MEMORANDUM

Re: Modifications to Design Review approval at approximately 255 S State Street:

Design Review - PLNPCM2019-00926

PROPERTY ADDRESS: 255 S State Street

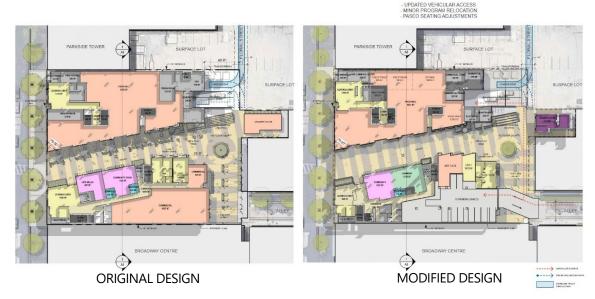
Revised Proposal: The proposed design primarily maintains the pallet of building materials that was approved by the commission; however, the fiber cement board has been replaced with an ACM metal panel. The revised narrative submitted by the applicant indicates the proposed

ACM metal panel will have a texture and pattern to give it a concrete appearance very similar to fiber cement.

The punched openings ("bump outs") have been removed from the building design, and 50% of the windows are proposed 2 feet wider and the energy rated glazing has been increased. The revised proposal maintains a similar staggering pattern to the original proposal. Windows are inset approximately 3-4 inches to create some shadow lines along the building façade.

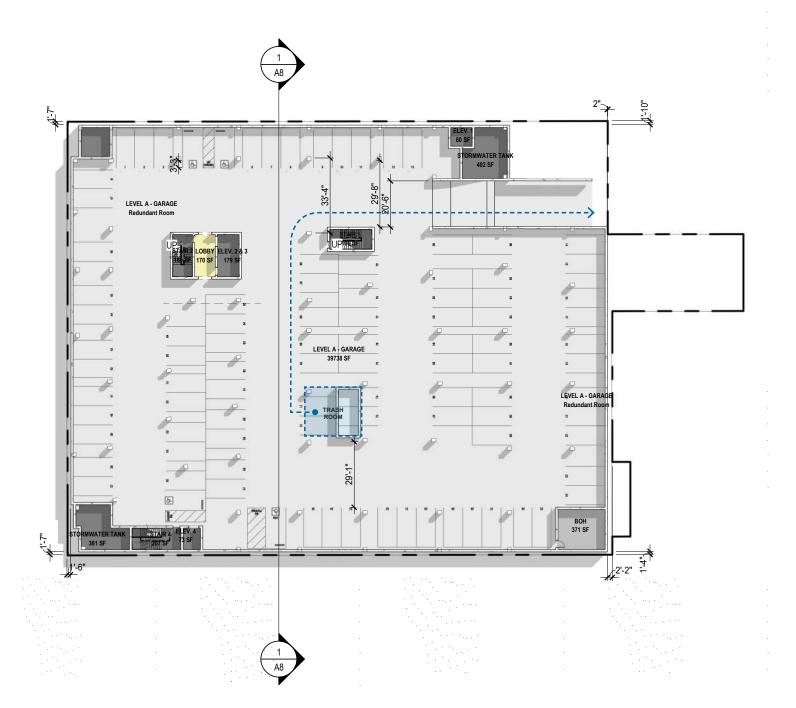
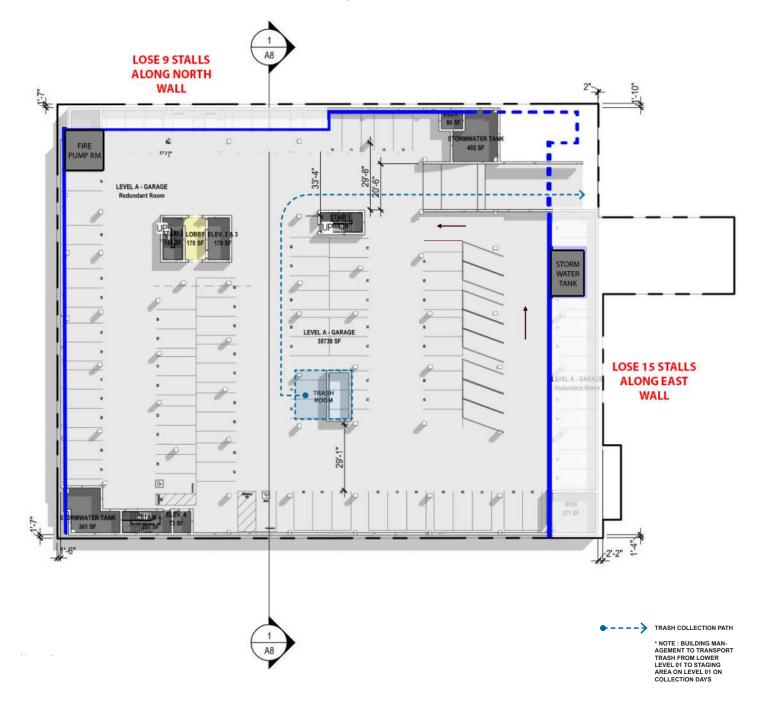
- REDUCED BELOW GRADE GARAGE FOOTPRINT
- PARKING REDUCED FROM 95 TO 81 SPACES

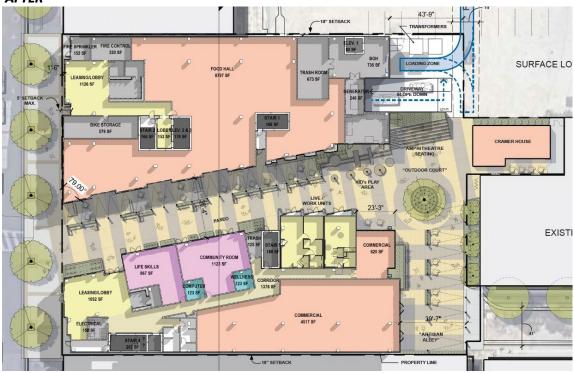
<u>Maximum Setback on State Street</u>— The initial design included a request to exceed the maximum 5-foot setback along State Street. The north building had setbacks that varied from approximately 8 ½ feet to 14 ½ feet and the south building had setbacks varying from 9 feet 10 inches to 33 ½ feet. The revised proposal complies with the maximum 5-foot setback requirements.
